# Heathrow Master Plan Consultation

## Response from HACAN

Figure 4.9: Preferred Proposals for Future Night Flight Operations

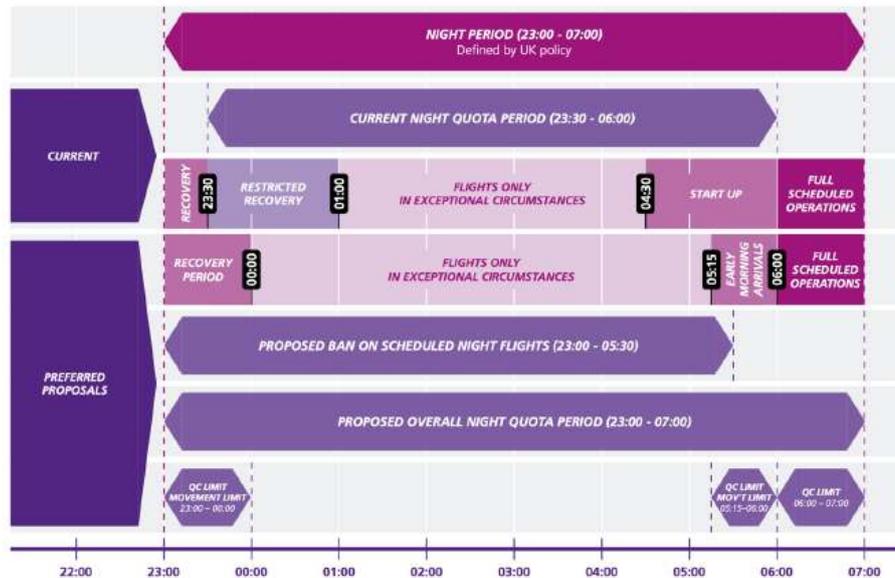
**However, there is concern that on the week communities would get flights the 6.5 hour break won’t be clear break.**

There are legitimate questions to be asked whether this amounts to a 6.5 hour period without flights as laid out in the National Policy Statement. Most of us would accept that there is a need to allow for flights in exceptional circumstances but may question whether the hour long ‘recovery period’ should be part of the 6.5 hour period without flights. There would be no scheduled flights during that period but should there be any flights at all? It does seem, though, that this shorter night period might be a trade-off for each community getting two weeks out of three for no flights before at least 6am. We would want to explore this with Heathrow after the consultation has closed.
